Design verification report

Design name: MASK_BIU01_fix.gds

Submission date: 23/1/2025

Summary of report: Design violations / errors present - resubmission required

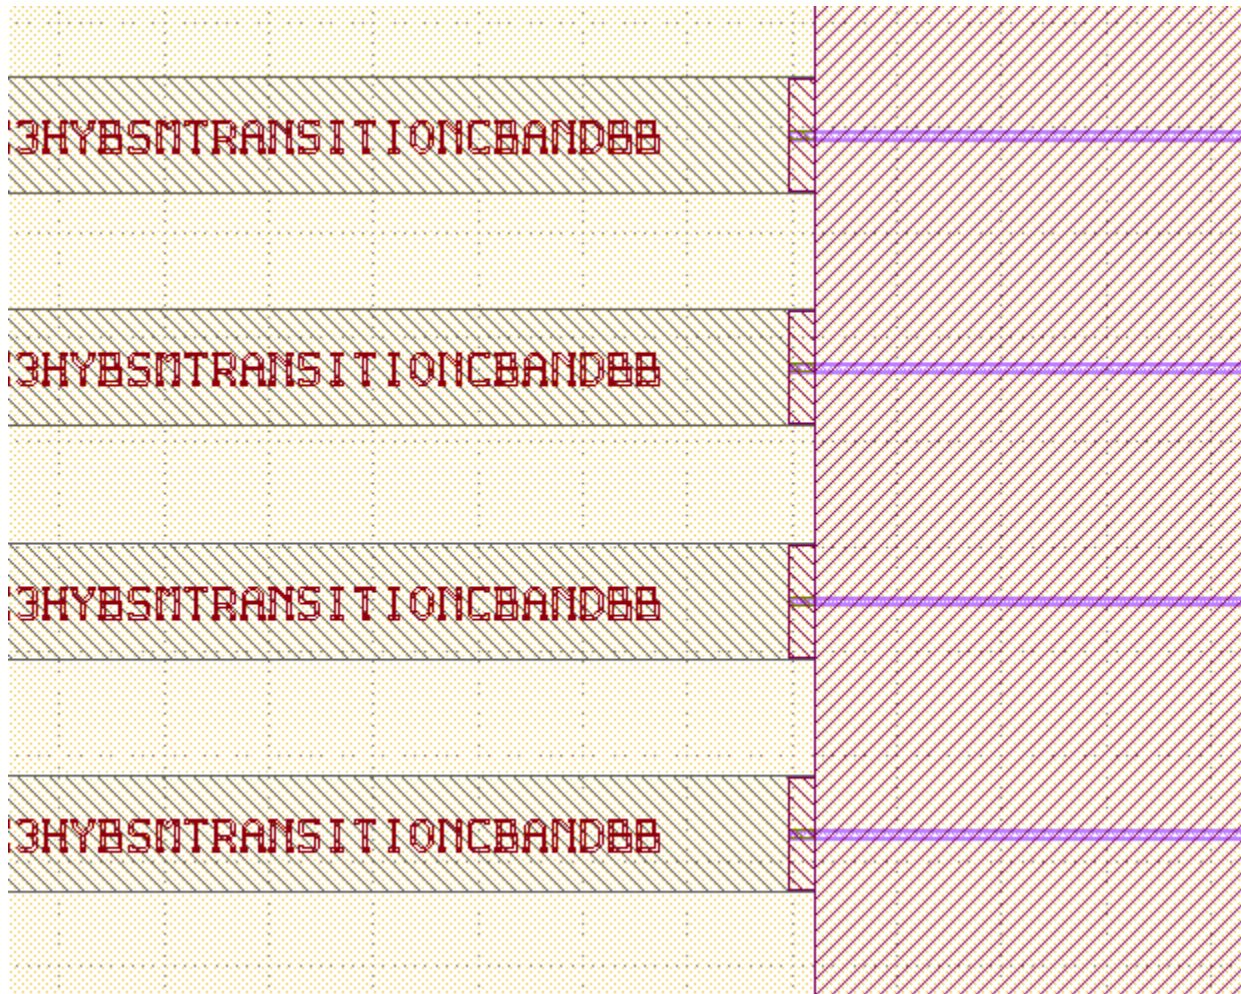
Thin metal lines will cause significant RF loss

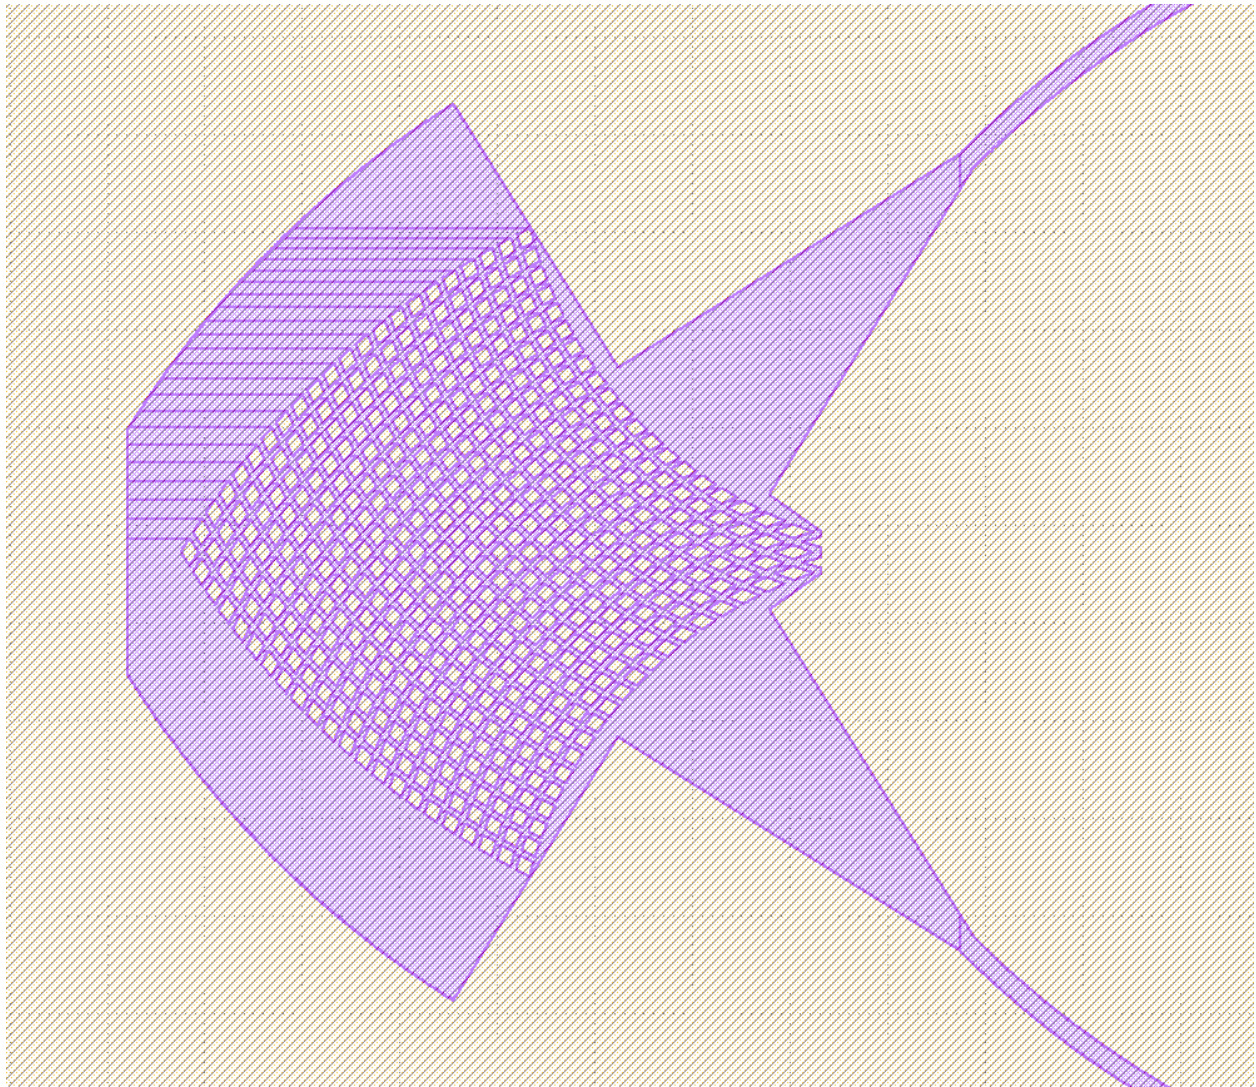
The hybrid mode uses layer 70/0, not 2/0

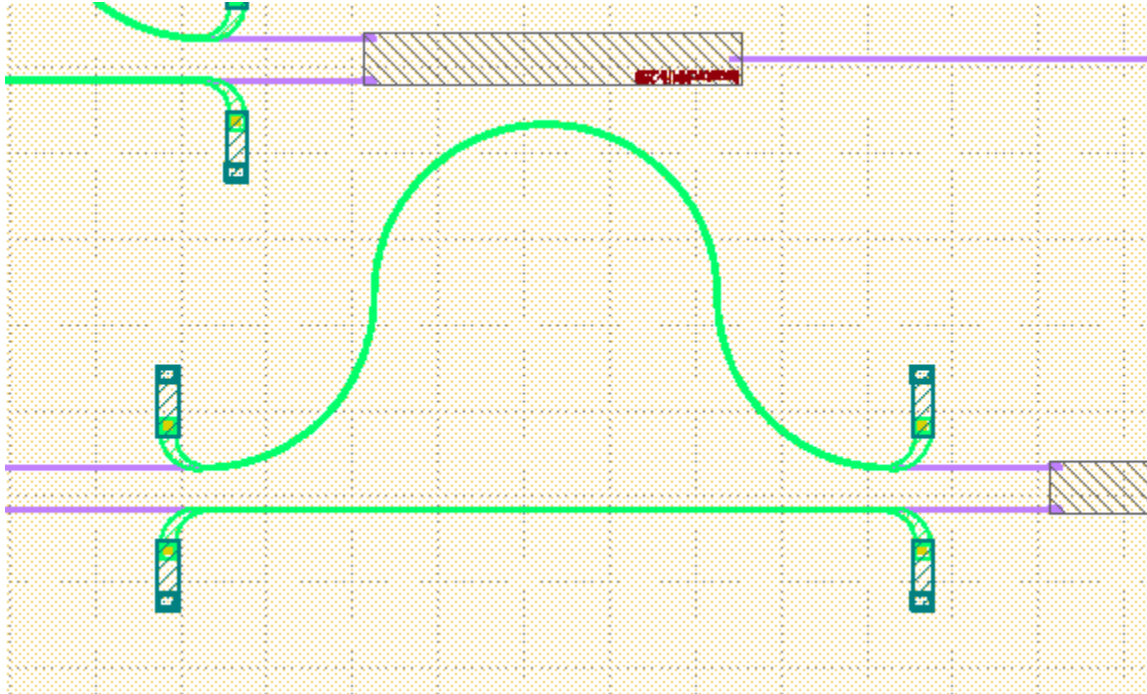
These structures will not be as well defined as what is drawn, there will be a lithography bias.

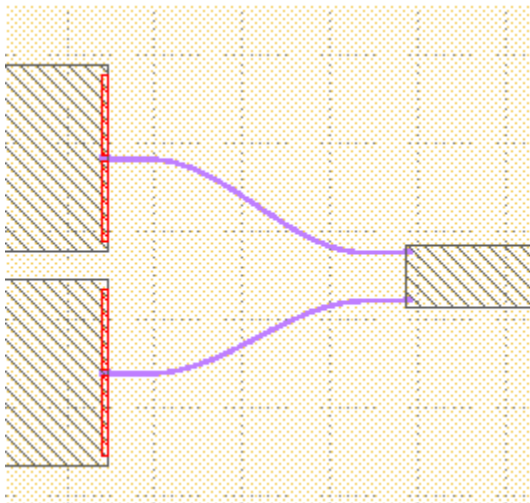
You must use the P1W design layers, as outlined in the LNA design manual

No RF termination. The pad layer is needed to access the metal lines in the modulator BB.
